Item Name: Fwd Crosstube - High 206L / L1 / L3 / L4

DART AEROSPACE LTD		Work Order:	140497
Description: Crosstube High Fwd (206L)		Part Number:	D206-667-103
Inspection Dwg: D206-667-143	Rev: C	Page 1 of 1

DRAWING NO. D206-667-143	TITLE CROSSTUBE ASS'Y (206L HIGH FWD)	REV. C	DART AEROSPACE LTD ENGINEERING ORDER		D.E.O. NO. D206-667-143-C-1	SHEET NO. SHEET 1 OF 1	SCALE NTS
DRAWN <i>qp</i>	CHECKED <i>ASS</i>	MFG. APPR. <i>128</i>	APPROVED <i>WD</i>		DE APPR. <i>WD</i>		
DATE 11.07.15	DATE 11.07.20	DATE 11.07.21	DATE 11.07.21		DATE 11.07.21

DETAIL P
BONDING STRAP INSTALLATION 2 PL

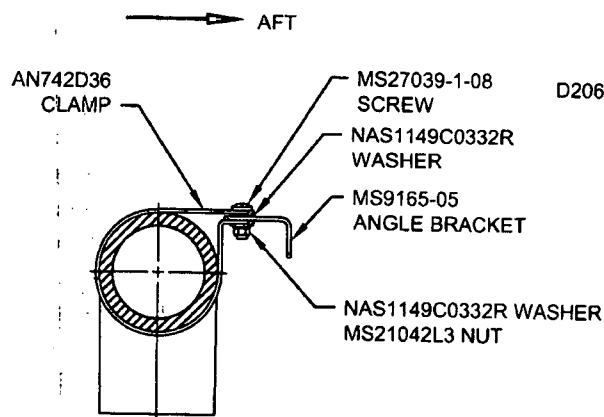
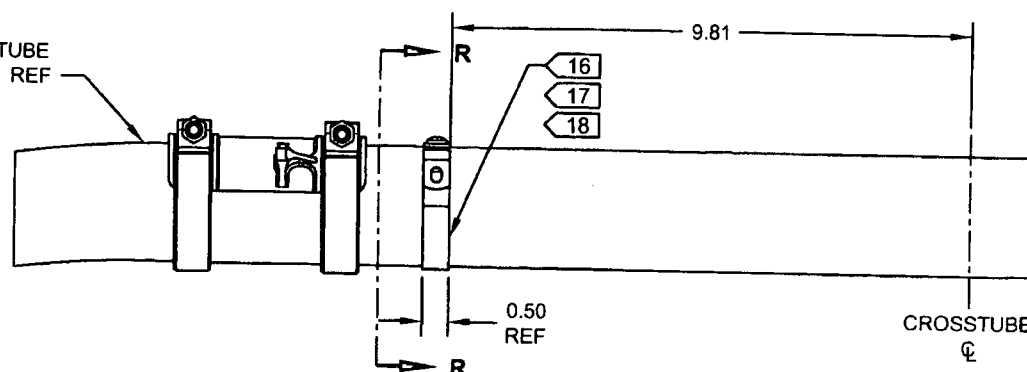
ADD ELECTRICAL GROUNDING STRAP

PARTS LIST:

ITEM	QTY -143	PART NUMBER	DESCRIPTION
1	X	D206-667-143	CROSSTUBE ASSEMBLY (206L HIGH FWD)
10	2	AN742D36	CLAMP
11	2	MS9165-05	ANGLE BRACKET
12	2	MS21042L3	NUT (OR MS21042-3)
13	2	MS27039-1-08	SCREW
14	4	NAS1149C0332R	WASHER (OR AN960C10L)
